**STATE OF HAWAII
DEPARTMENT OF TRANSPORTATION
HIGHWAYS**

**ADDENDUM NO. 2
FOR
TRAFFIC SIGNAL MODERNIZATION, OAHU, PHASE 2A
DISTRICT OF HONOLULU
ISLAND OF OAHU
FEDERAL-AID PROJECT NO. STP-0300(214)**

NOVEMBER 8, 2024

FED. ROAD DIST. NO.	STATE	PROJ. NO.	FISCAL YEAR	SHEET NO.	TOTAL SHEETS
HAWAII	HAWAII	STP-0300(214)	2024	ADD.100	149

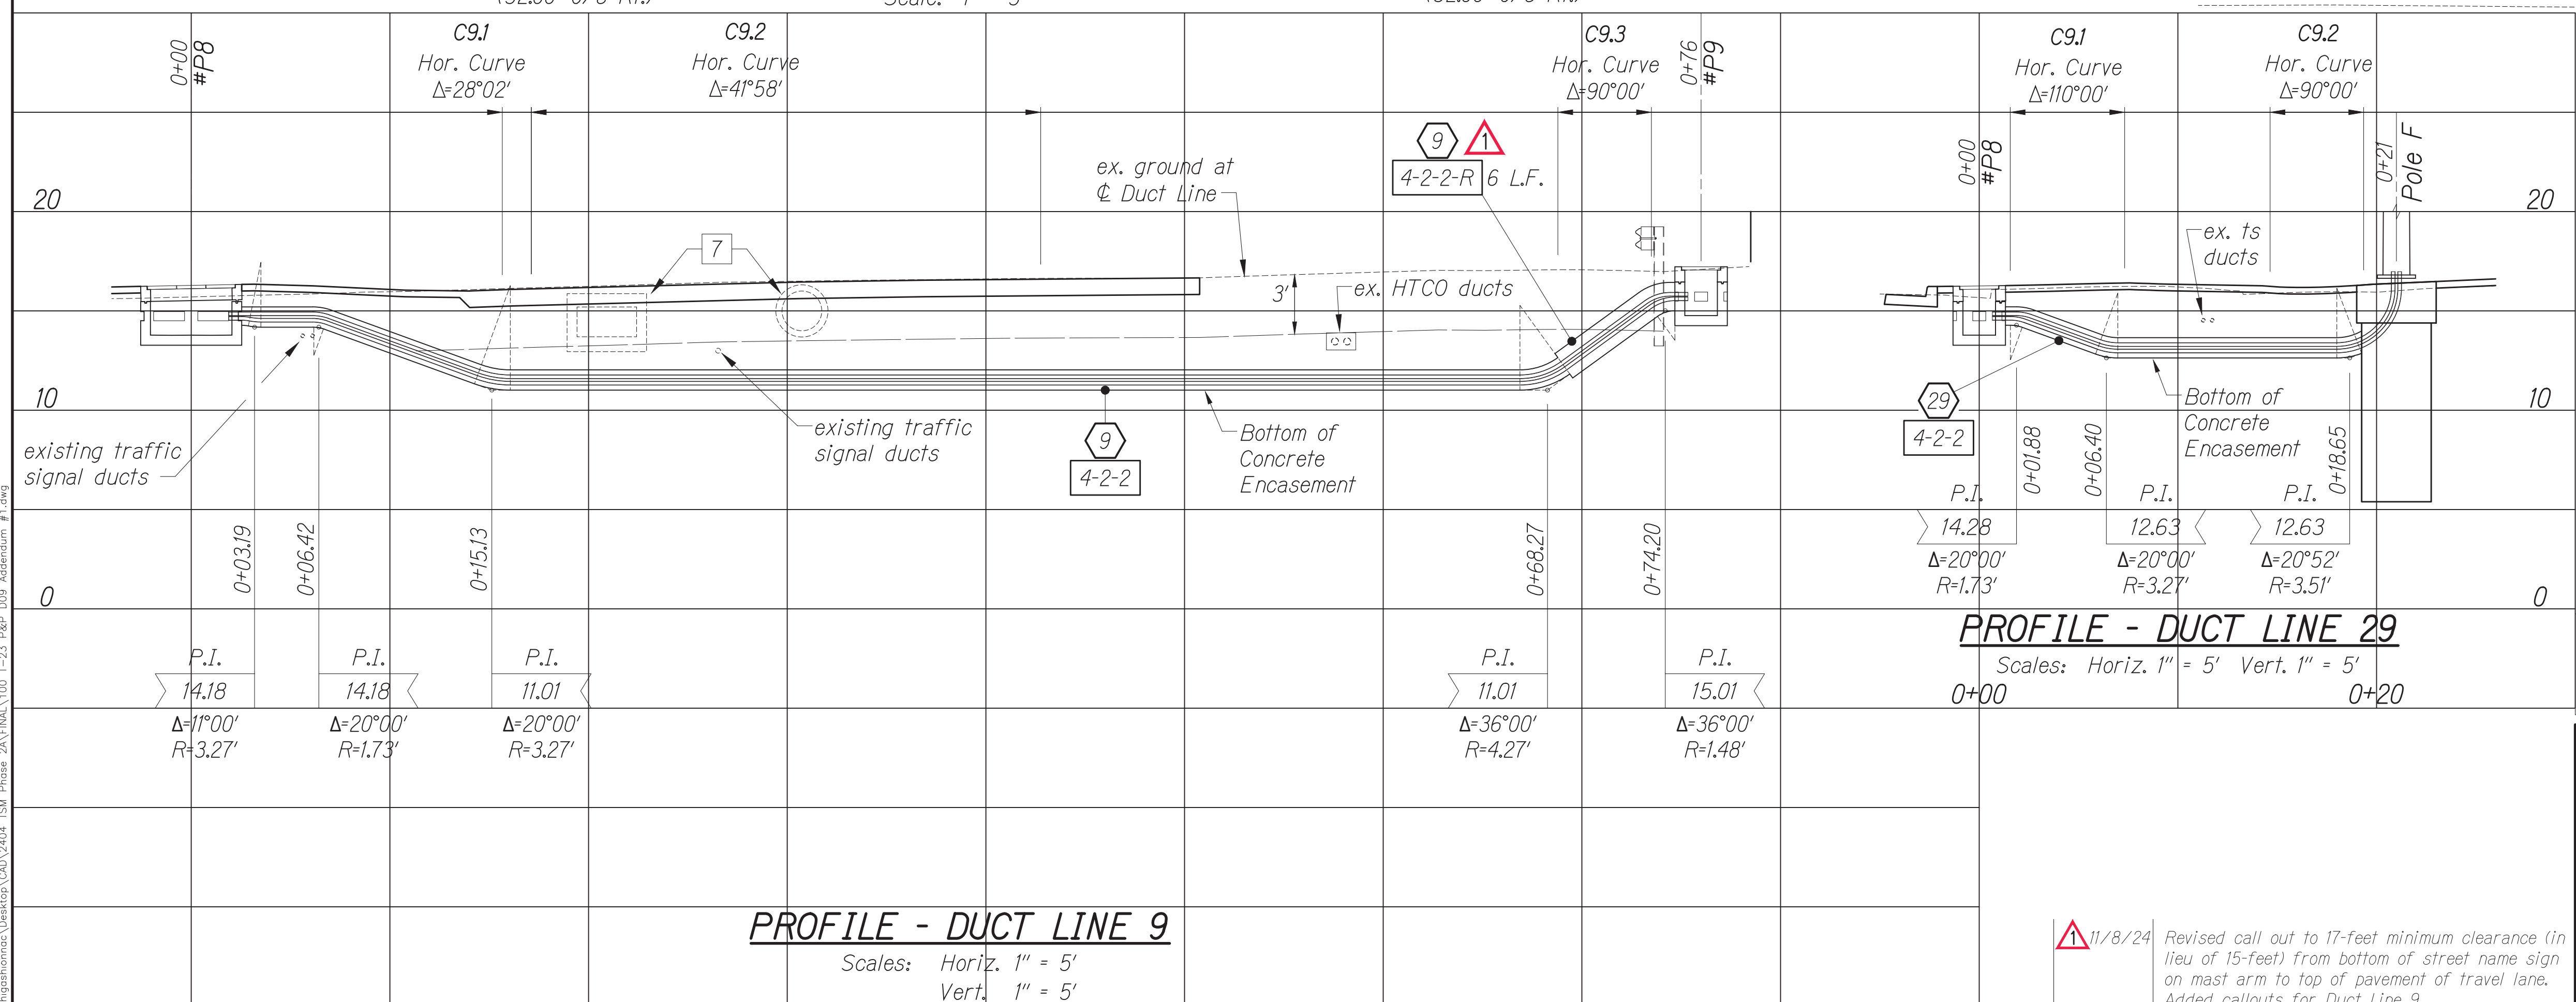
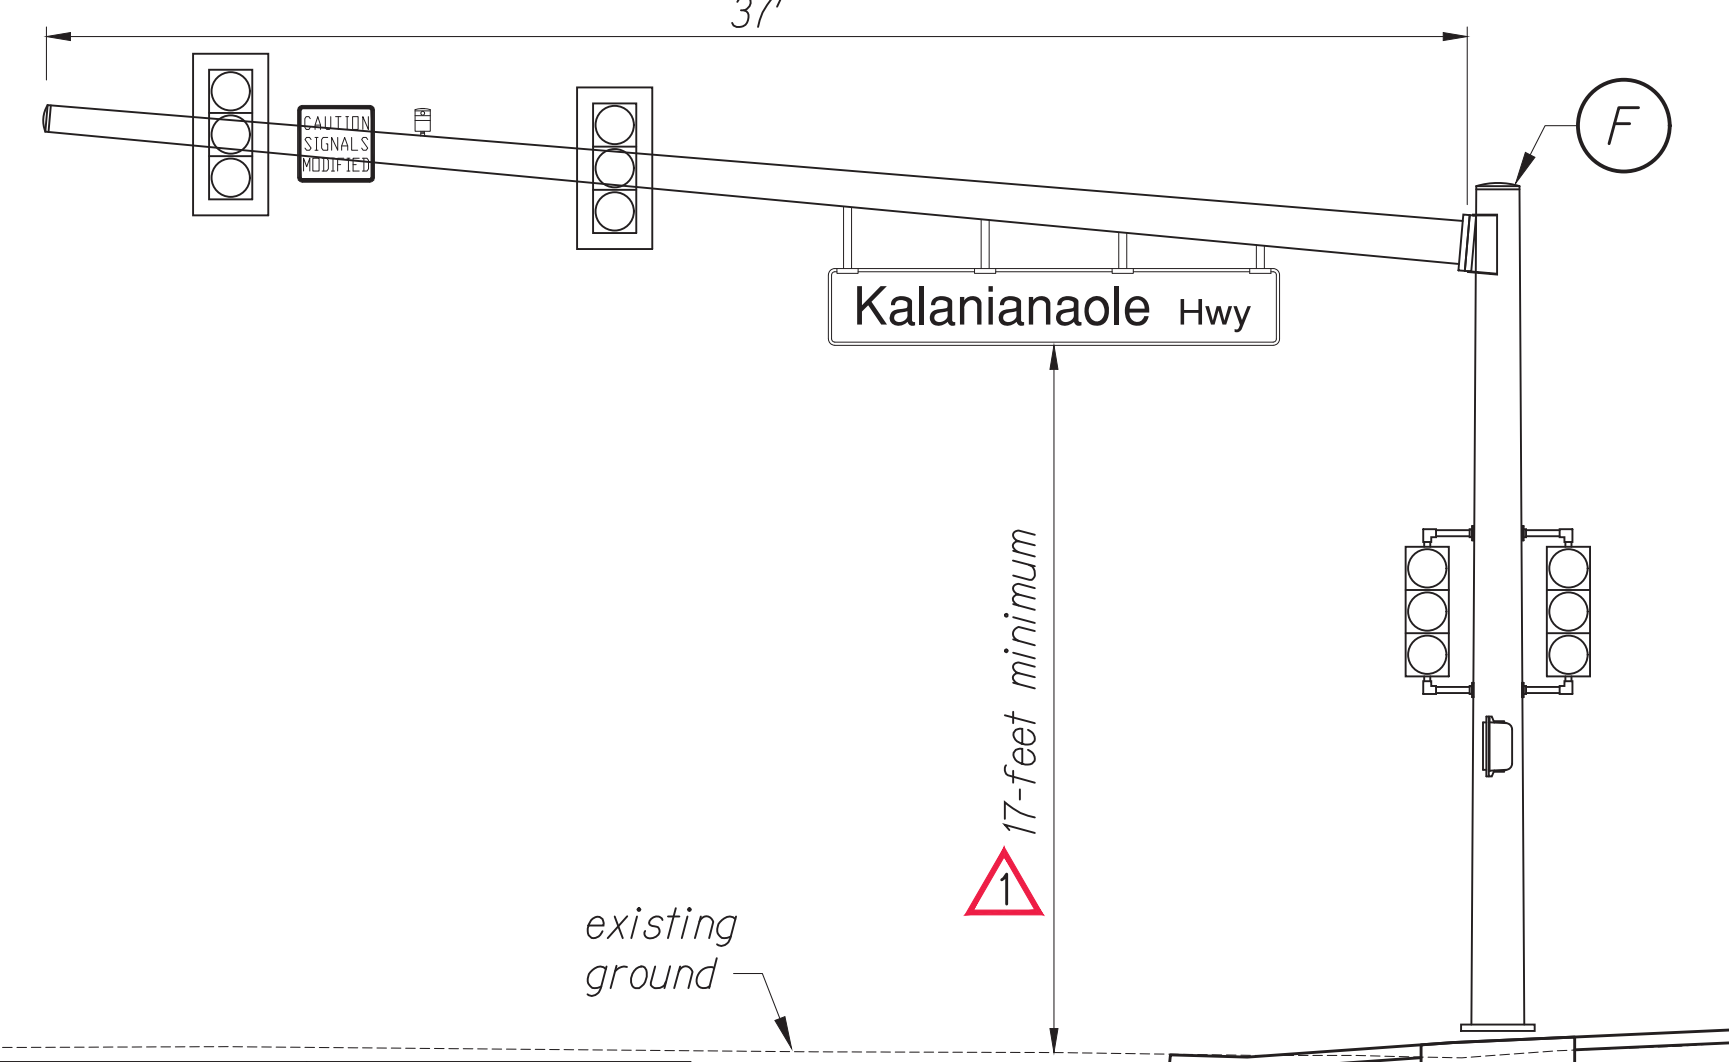
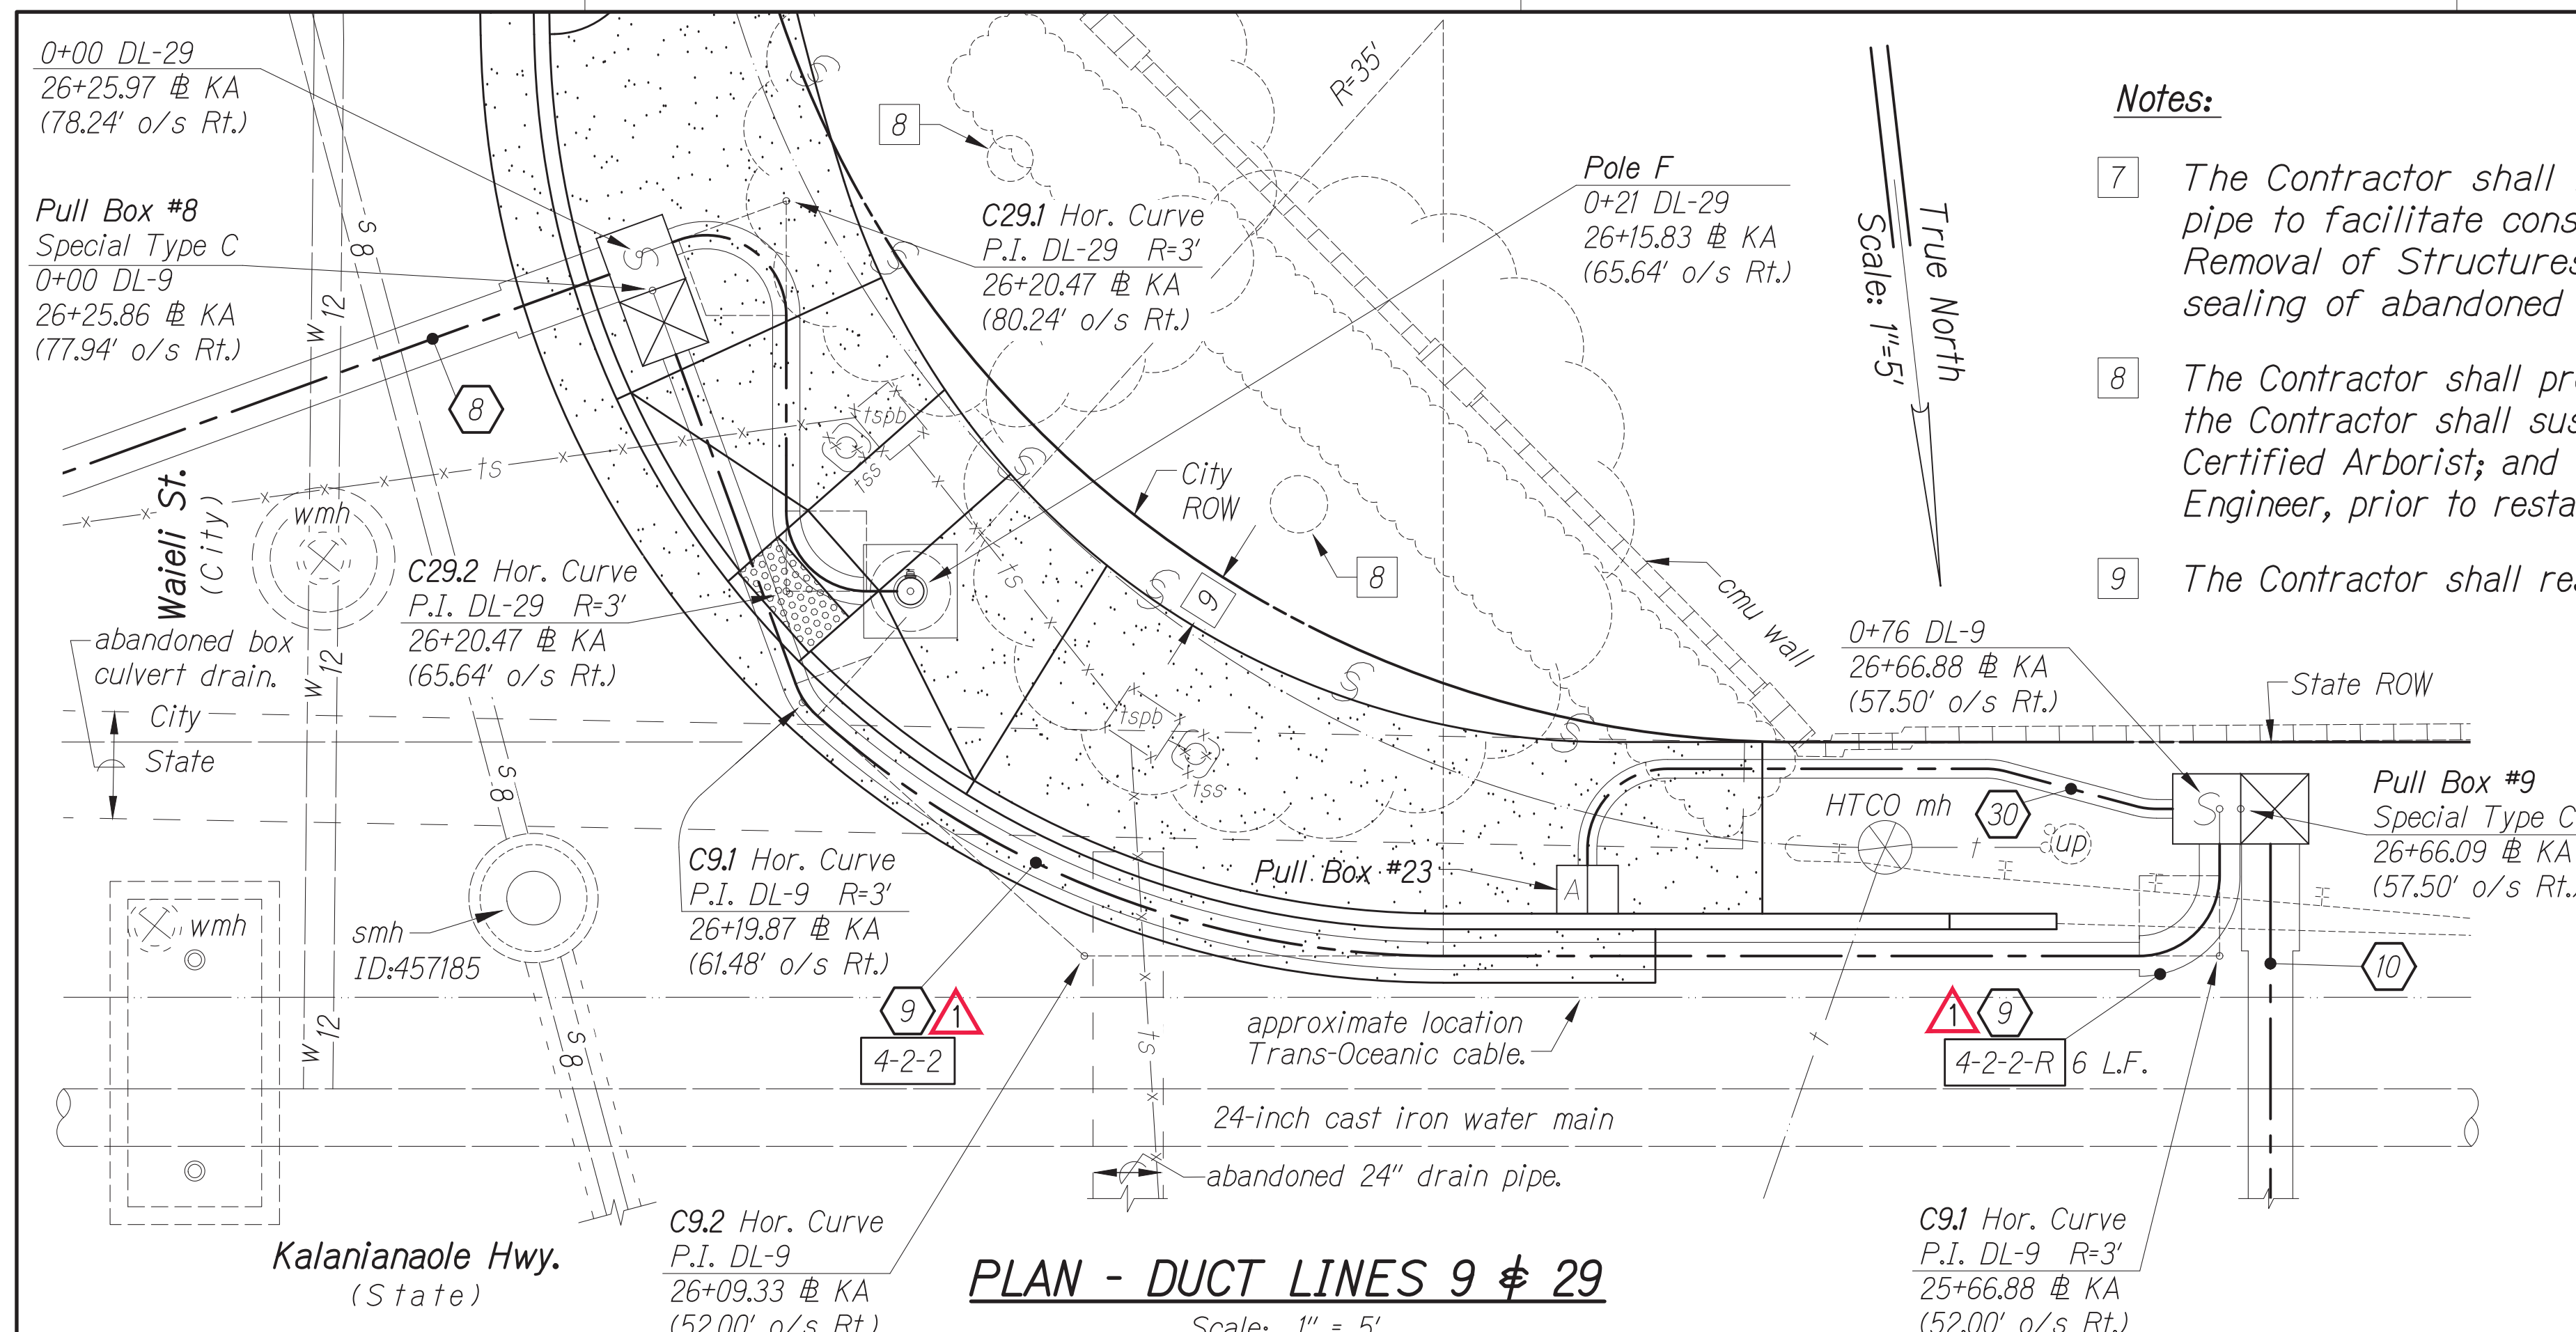
DATE	REVISION
11/8/24	Revised call out to 17-foot minimum clearance (in lieu of 15-foot) from bottom of street name sign on mast arm to top of pavement of travel lane. Added callouts for Duct Line 9.
